Field Bulletin

- Interface Card Connector
- SC66/83 XX X

Bulletin #: FG07006

Subject: Contact stabilization feature added to SC Interface Board Connector.

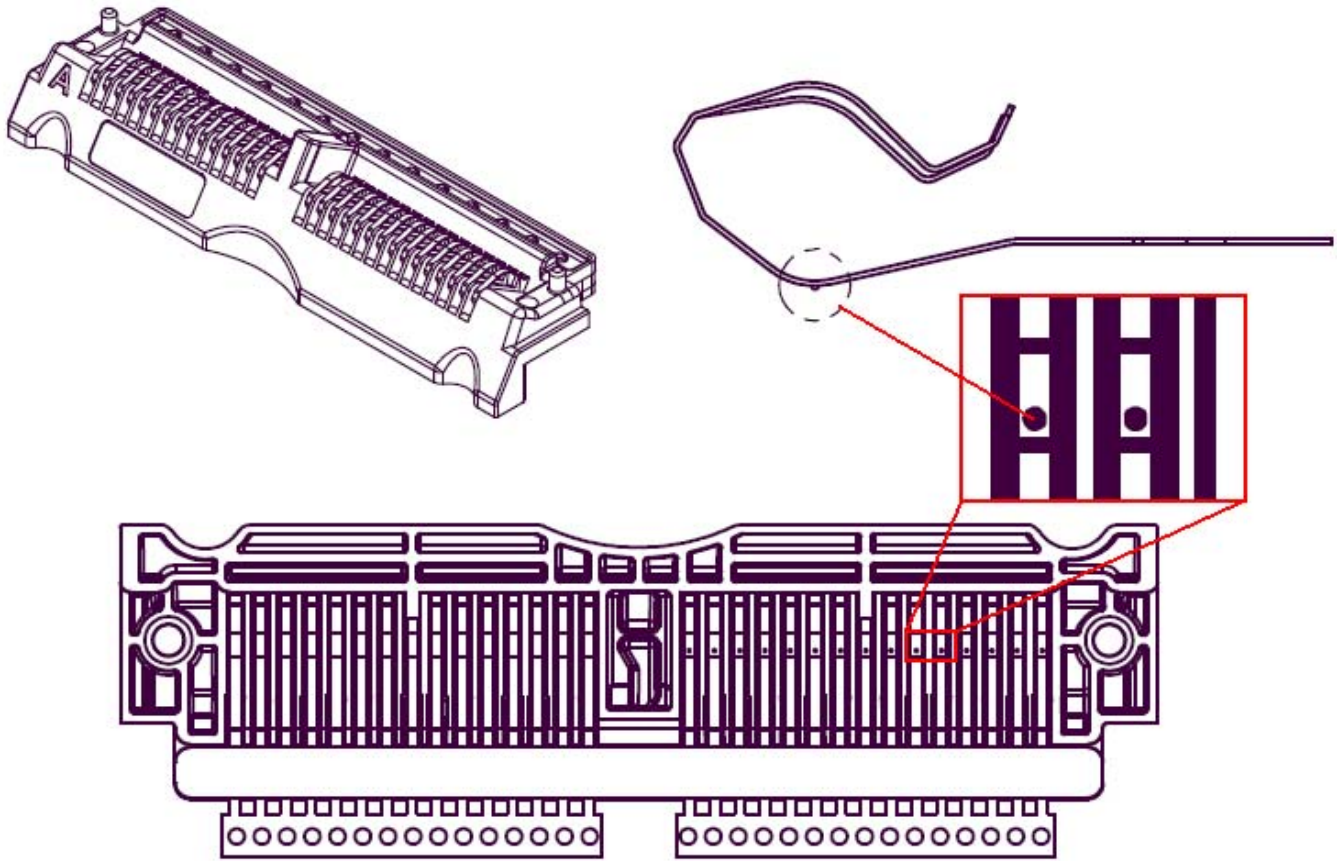
MEI has made a design change to the SC interface PCB connector. The connector part number has been changed from 252074039 to 252079045. This change does not effect the part number of the Interface PCB PN: 252016090P1. Classified as a product enhancement, the change increases connection stability between the interface board and the connector by adding a raised dimple to the connector contacts. See figure below for details.
